AMERICAN FORK CITY PLANNING COMMISSION
MAY 6, 2020
NOTICE OF ELECTRONIC MEETING
REGULAR SESSION

AMERICAN FORK CITY
PLANNING COMMISSION

AGENDA TOPIC: Review and action on a commercial site plan for American Eagle Ready Mix, located in the area of 1700 South 500 East, in the I-1 (Industrial) zone.

RE: American Eagle Ready Mix Site Plan Application
American Fork City Planning Commission Regular Session – March 18, 2020

SHEET NUMBER:
S000

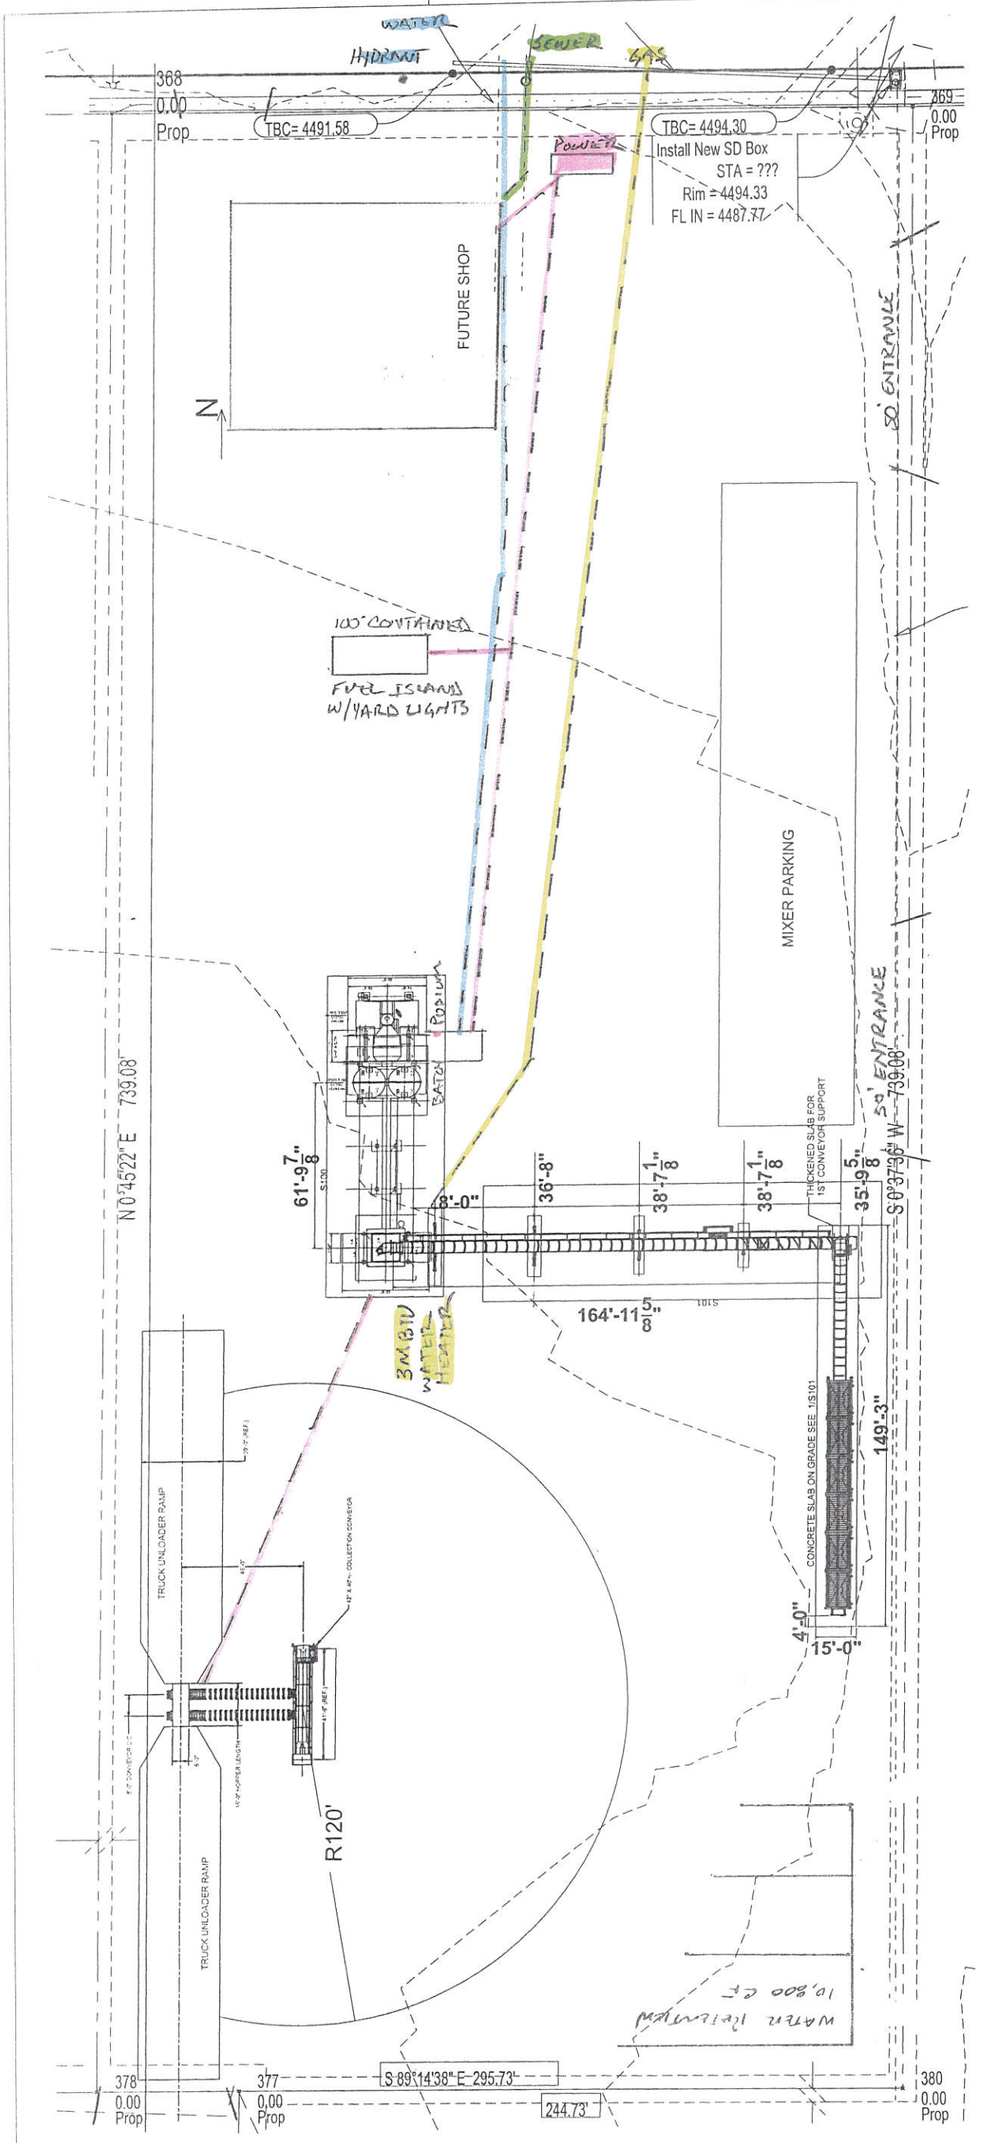
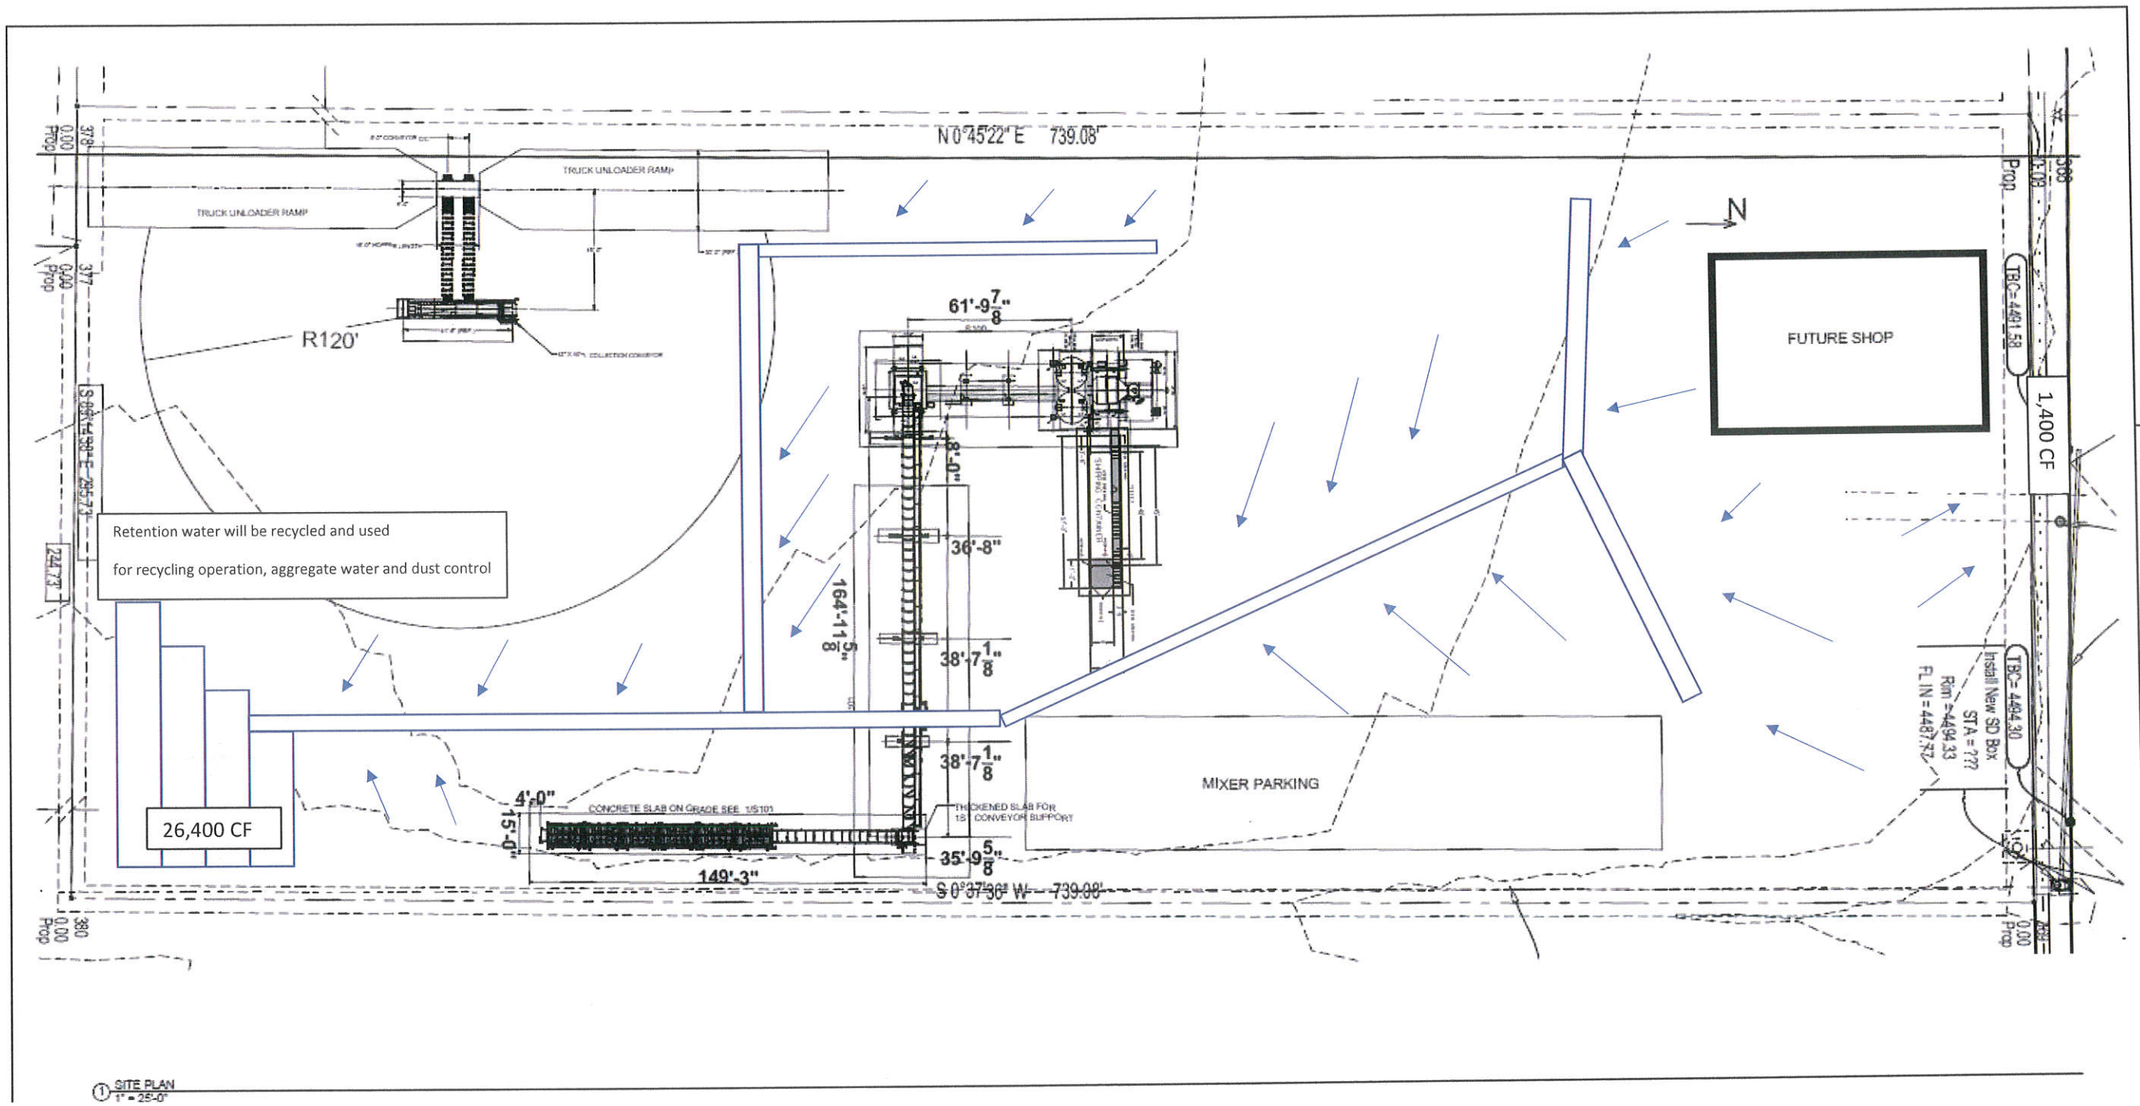
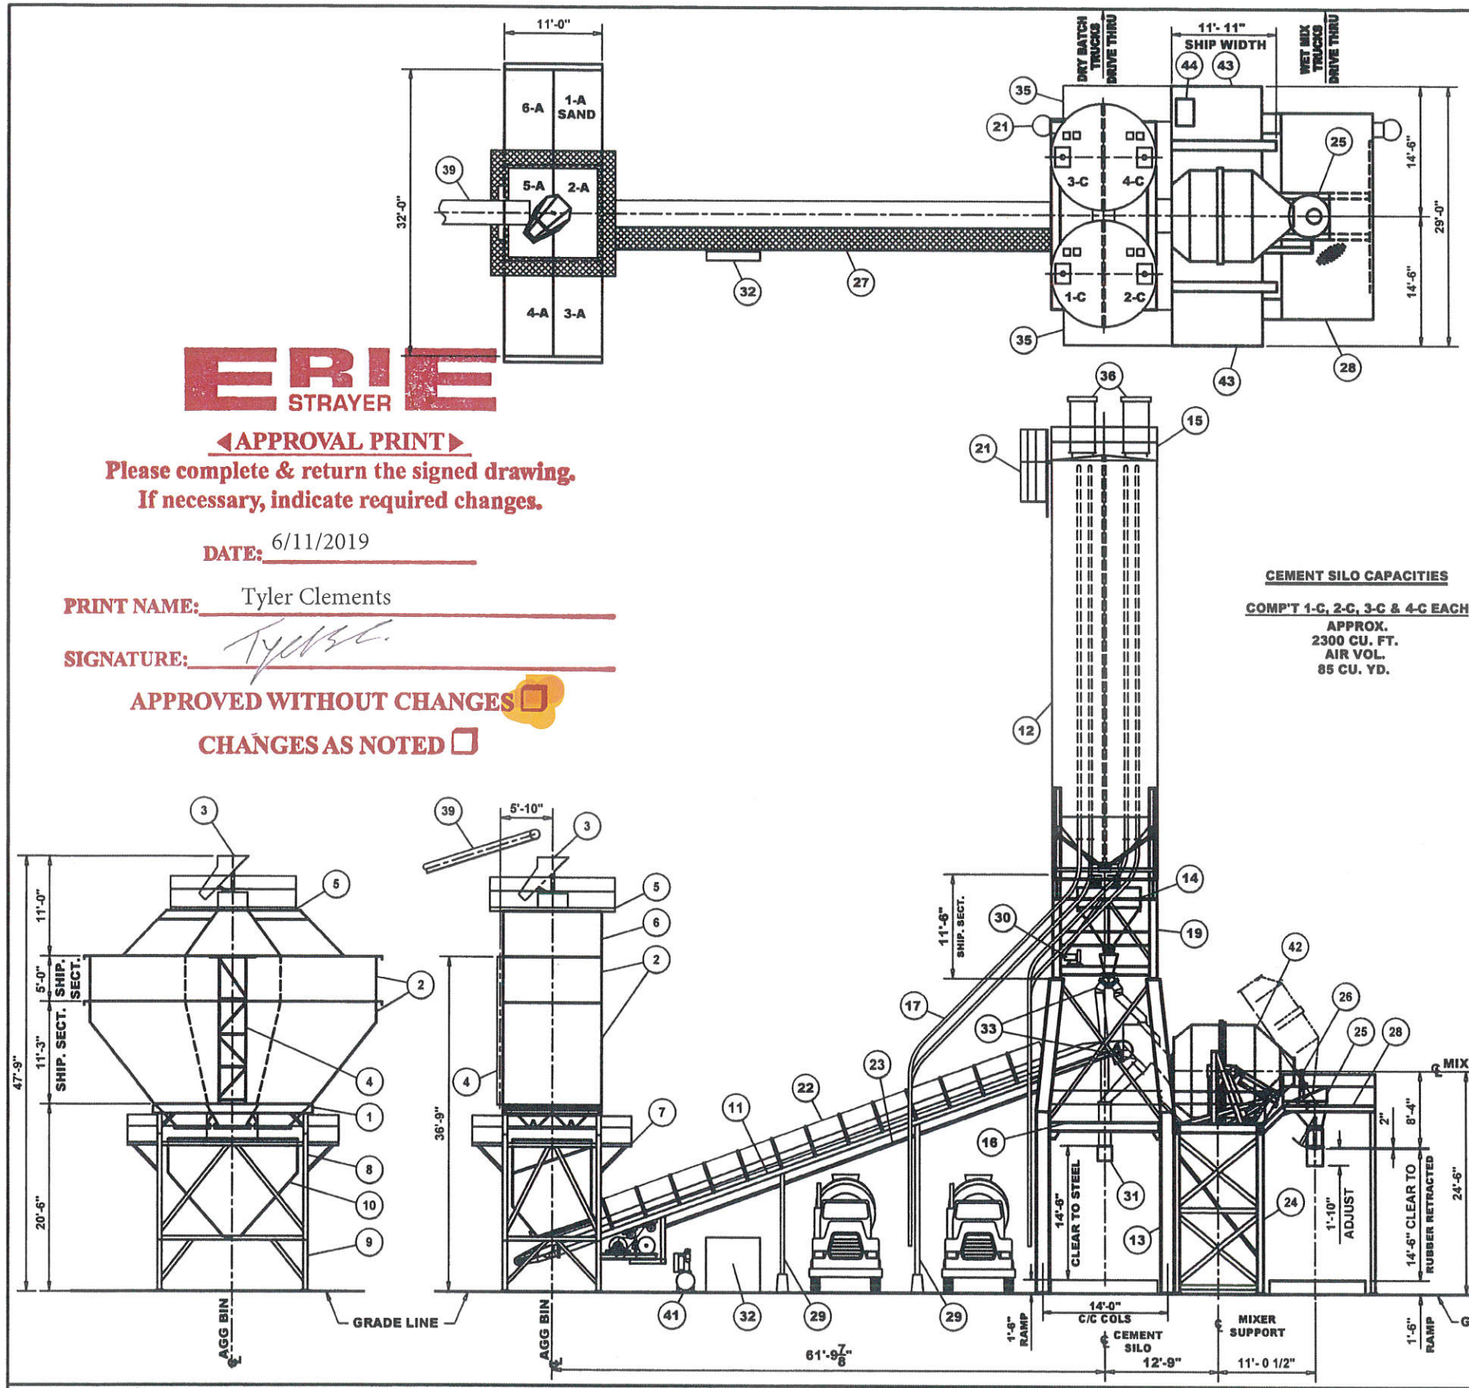
The site plan illustrates a proposed structure toward the north end of the property, south of 1700 South. The I-1 zone requires a 30' front setback for structures. Verification of front setback is required. Verification of adherence to landscape requirements is also unclear and should be addressed. Specifically, the following: (1) landscape islands adequately sized at the end of all parking rows, (2) shade trees provided at the ratio of 1 tree per 6 parking stalls and 1 shrub per 25 sq. ft. of landscape island, (3) 6' wide parking perimeter landscape area, and (4) a 14' wide landscape area adjacent to a street frontage with 1 tree provided for every 40' of street frontage.

A landscape plan is provided; however, it does not appear to address specifics required by the City's landscape requirements. Revision is needed to ensure compliance.

This has not been illustrated on the site plan.

The applicant has submitted a revised site plan, illustrating compliance with setback and landscape requirements. The applicant has also prepared a letter addressing the Planning Commission, identifying items of concern raised at the April 8th meeting, and how those will be addressed (see attached letter and site plan).
